Dr James Ward, 84 Connaught Street, Phibsborough, Dublin 7, D07 YV02

Re: CPO: Blanchardstown Bus Corridor, Case Reference: KA29N.313961

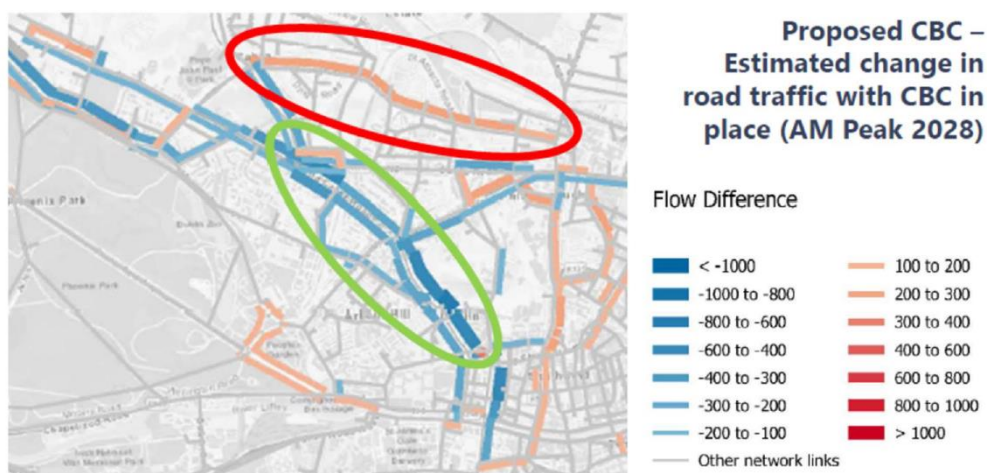
There are three road restriction changes proposed in the CPO application for the Blanchardstown Bus Corridor, none of which were set out in any of the proposed designs issued for public consultation since the Bus Connects project commenced in 2018.

The final preferred route was the result of three separate and rigorous stages of consultation since 2018 and yet none of the three proposed restrictions appeared in the [final preferred route](#) publication dated March 2022.

A number of changes were negotiated at a local level with residents' groups, in particular **Annamoe Road and Annamoe Terrace** (ref. BI) residents and their efforts to ensure their road does not become a "rat run," arising from the displaced traffic from the Old Cabra Road has meant significant changes to the original proposal which has dire consequences for our area. It is not clear why one resident's group would be successful in their endeavours to engage with the NTA to the severe detriment of another area such as mine.

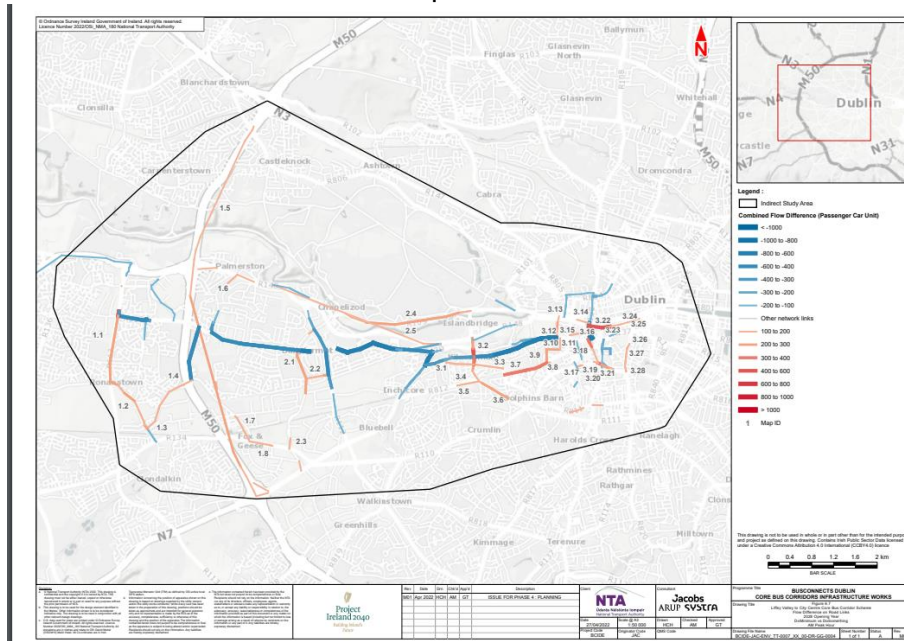
- **Flawed classification system of the impacts which sees areas forecast to experience an 80% increase in traffic flows being described as a “low impact” change.** In appendix A6.4 of the EIAR, Impact Assessments, the following are estimated when comparing a “Do Minimum” with a “Do Something” (i.e., BusConnects) scenario at PM peak hour:
 - An 80% increase in hourly traffic flows at the junction of Connaught Street and Shandon Crescent,
 - A 55% increase in hourly traffic flows at the junction of Fassaugh Ave and Dingle Road,
 - A 64% increase in hourly traffic flows at the junction of Fassaugh Ave and Bannow Road.

Each is described as having “not significant” effect and “negligible” impact. I can tell you as a resident of Connaught Street there is no way that changes of this nature can be considered “not significant” and “negligible” in their impacts on our abilities to go about our daily lives and live in a safe environment!

Furthermore, there is an estimated 70% increase in peak hourly traffic flows at the junction of Connaught Street and St Peter’s Road. This was described as being a “low impact” with “moderate” effect. It appears that only areas that are forecast to experience increases in traffic volume to beyond 85% of road capacity are classified as having any impact at all.

In effect, the classification minimises and deliberately downplays the traffic impacts arising from the proposed changes and this is simply inappropriate both for vulnerable road users but also for those living in these areas. Additionally, it doesn’t provide baseline data for the current traffic flow in any area it is impossible to know how much of an impact it will have on residents of my road and surrounding areas as it is impossible to make a “like for like” evaluation.
